**Pennsylvania Department of Environmental Protection's Comments On:
Draft Report – Little Blue Run Dam Inspection Report
Bruce Mansfield Power Plant
Beaver County, Pennsylvania**

Thank you for the opportunity to review and comment on the draft report for the Bruce Mansfield Plant - Little Blue Run Dam. Our comments fall into three categories:

Assessment of Dam Safety Coal Combustion Surface Impoundments (Task 3) Draft Report

Bruce Mansfield
Power Plant
Little Blue Run Dam
Shippingport, Pennsylvania

SITE PHOTO PLAN
KEY SITE FEATURES
LITTLE BLUE RUN DAM
SHIPPINGPORT, PENNSYLVANIA

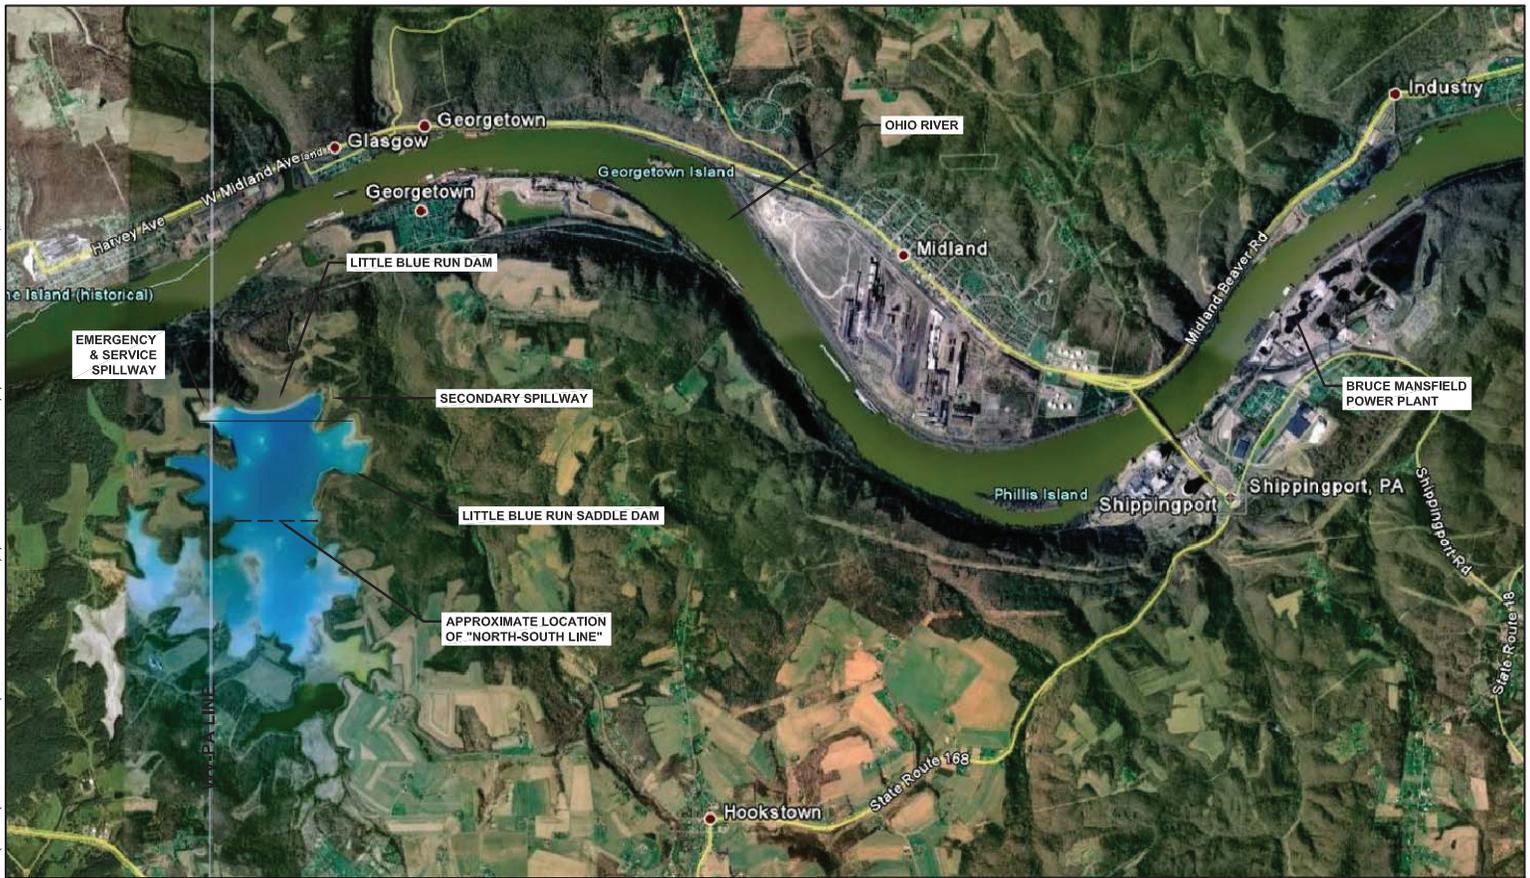
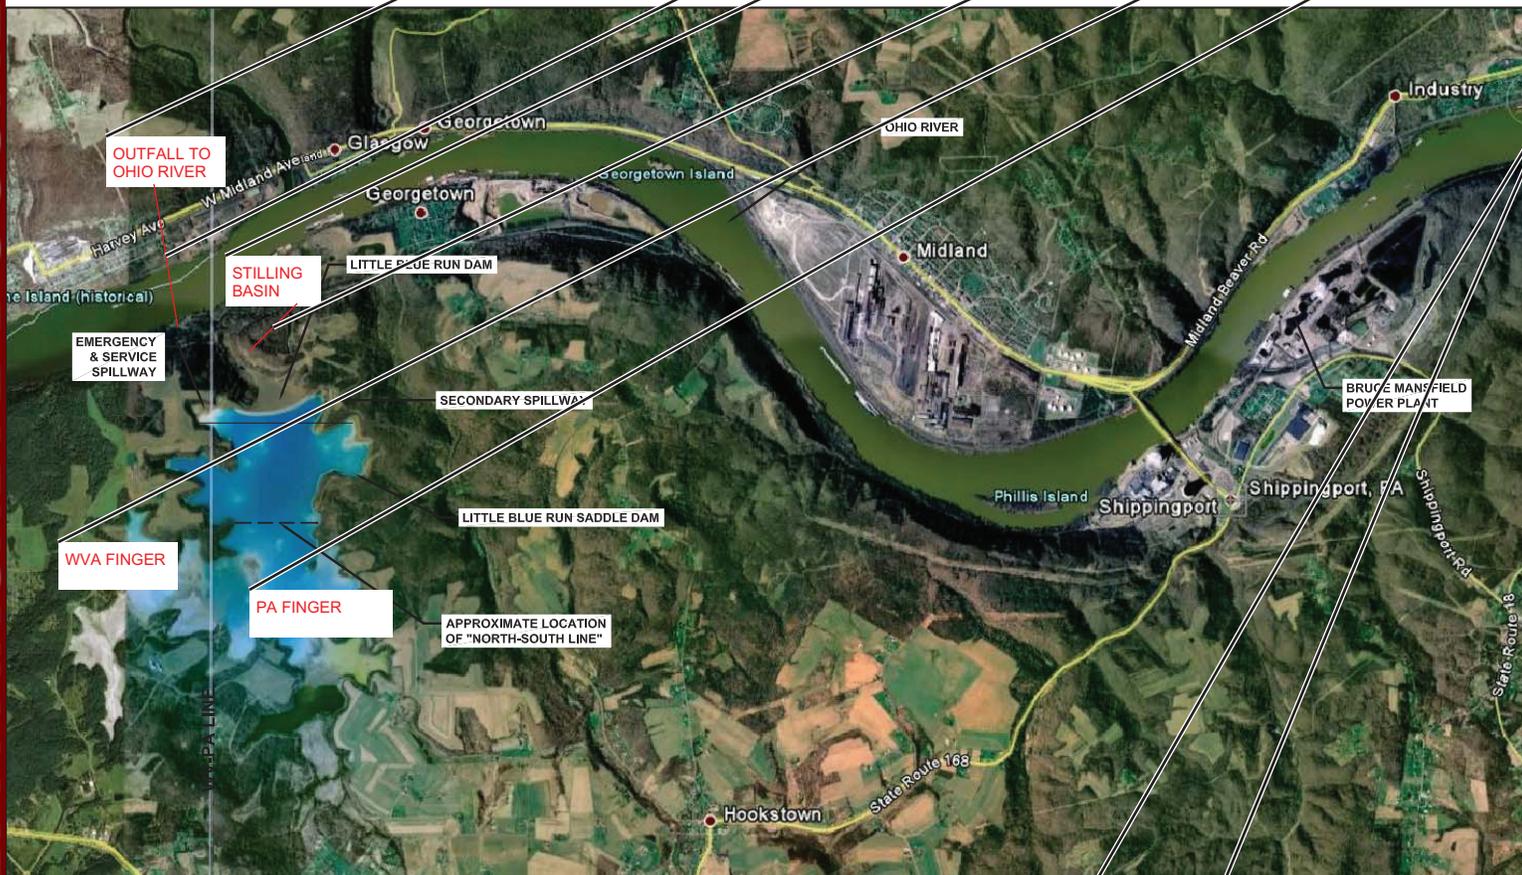
Figure 2 – ~~Photo Plan~~ shows the location of the Little Blue Run Dam and the Bruce Mansfield Power Plant. The dam is located approximately 0.6 miles south of the Ohio River and approximately 4 miles west of the Bruce Mansfield Plant.

☰	Author: michasr	Subject: Text Box	Date: 1/6/2010 2:22:20 PM	
☰	Author: michasr	Subject: Text Box	Date: 1/6/2010 2:23:09 PM	1
	OUTFALL TO OHIO RIVER			
/	Author: michasr	Subject: Line	Date: 1/6/2010 2:24:36 PM	1
☰	Author: michasr	Subject: Text Box	Date: 1/6/2010 2:22:26 PM	1
	STILLING BASIN			
/	Author: michasr	Subject: Line	Date: 1/6/2010 2:27:20 PM	1
☰	Author: michasr	Subject: Text Box	Date: 1/6/2010 2:23:43 PM	1
	WVA FINGER			
☰	Author: michasr	Subject: Text Box	Date: 1/6/2010 2:24:04 PM	1
	PA FINGER			
/	Author: michasr	Subject: Line	Date: 1/6/2010 2:30:50 PM	1
☰	Author: michasr	Subject: Text Box	Date: 1/6/2010 2:31:14 PM	1
	KEY SITE FEATURES

SECTION A-A

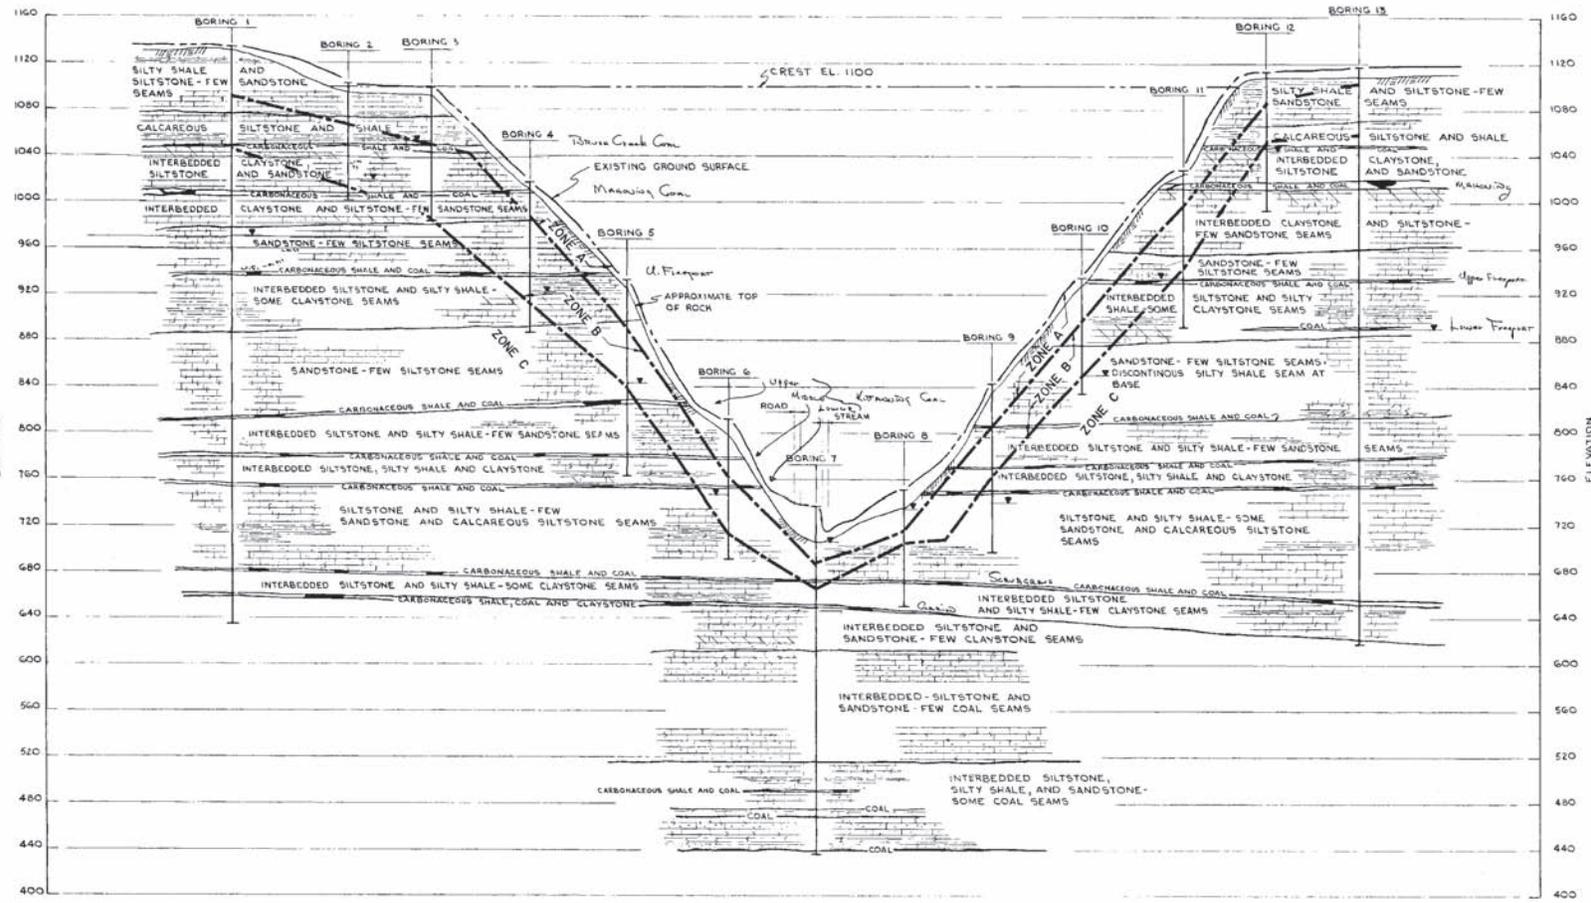
Insert following cross section. 2

SECTION B-B

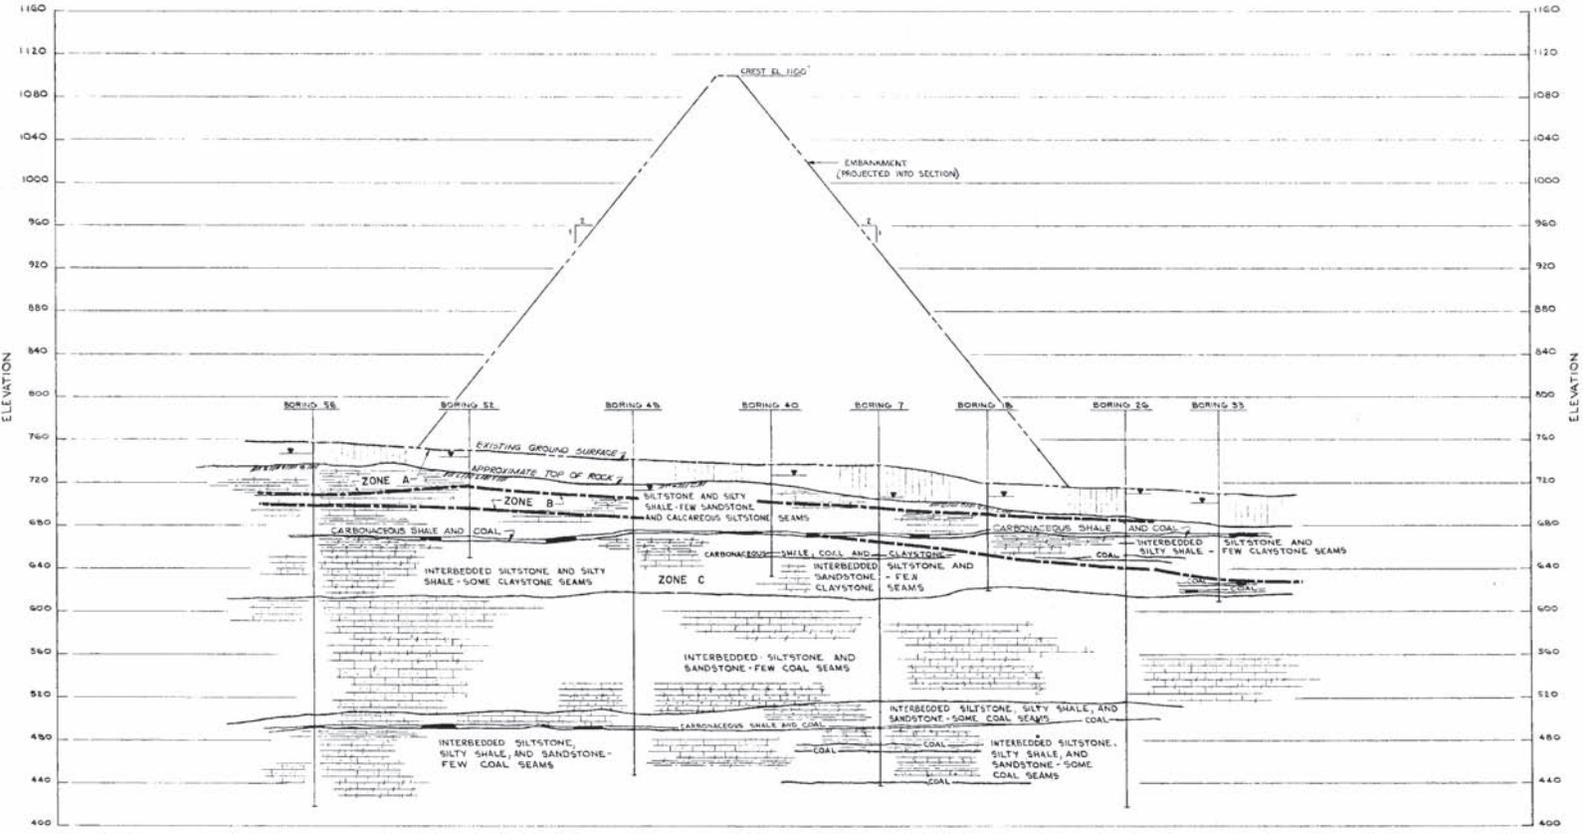
Insert following cross section. 2

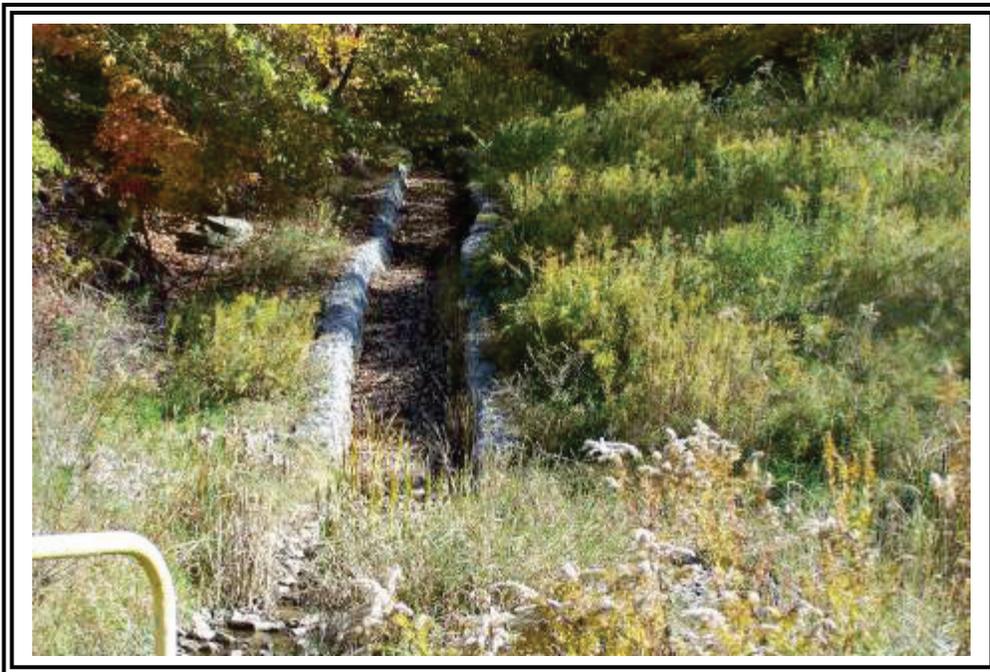
-
-  Author: cargol Subject: Replacement Text Date: 1/26/2010 4:03:27 PM 1
Service Spillway right-of-way looking upstream from the stilling basin.
-
-  Author: cargol Subject: Replacement Text Date: 1/26/2010 4:05:11 PM 1
Impoundment side of Secondary Spillway approach channel. Pipe was submerged during our site visit.
-
